X 91.142-26

MODEL 250 RX, 244 GX

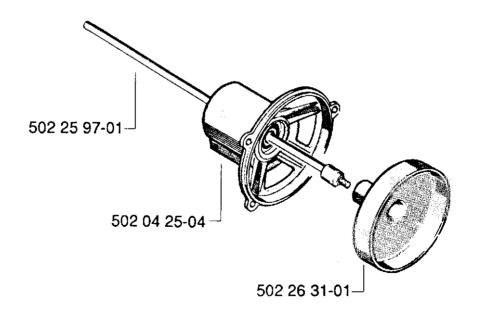
In order to reduce the load on the upper bushing in the tube, a clutch cover with double ball bearings is introduced.

At the same time, the attachment between the drive shaft and the clutch drum is changed from splines to threads.

The change is introduced from serial number 250 RX -1100186 $244~\mathrm{GX}$ -1190001

NOTE! The new parts (clutch cover, clutch drum and drive shaft) must always be mounted together.
